**HISTORIC PRESERVATION REVIEW BOARD  
STAFF REPORT AND RECOMMENDATION**

Landmark/District: **Foggy Bottom Historic District** (x) Agenda  
Address: **2431 I Street NW**

Meeting Date: **September 18, 2014** (x) Addition  
Case Number: **14-625**

Staff Reviewer: **Tim Dennée** (x) Concept

### **Windows**

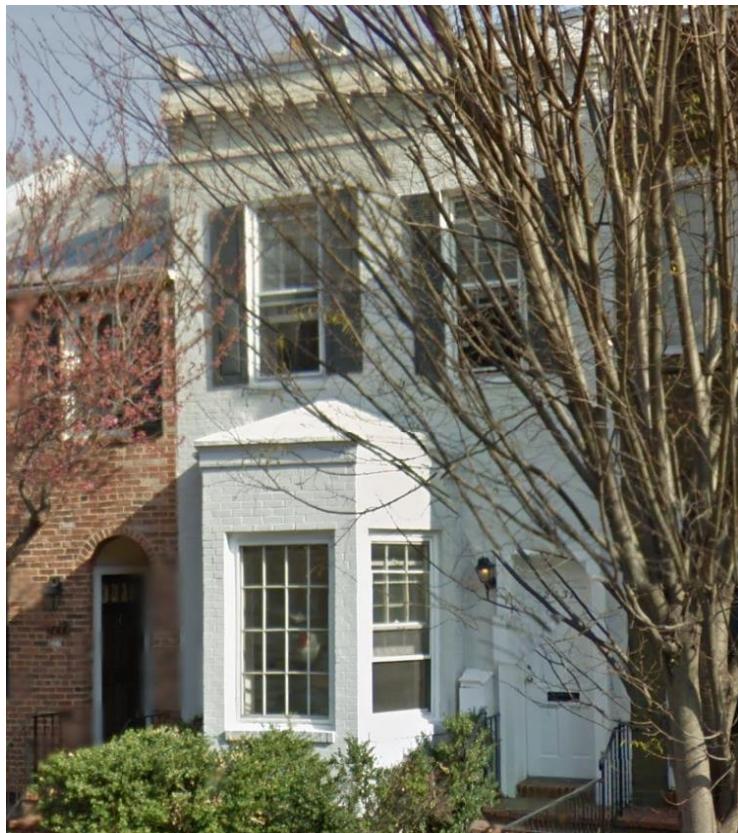
The other alteration proposed is the replacement of the front windows. Four six-over-six double-hung windows would be replaced with two-over-two windows, the latter configuration being more typical of the style and period of the subject building. A fifth window, a fixed sixteen-light window in the face of the bay projection, would apparently be replaced with a single-light picture window. While the bay has been reconstructed over the years, the front windows should be consistent throughout, two-over-two double-hungs.

*The HPO recommends that the Board find the concept to add a partial third story to be incompatible with the character of the historic district but support the concept for an addition similar to that proposed, but at the height of two stories, with the conditions that its cladding be a true stucco and that the façade's replacement windows be appropriate two-over-twos.*
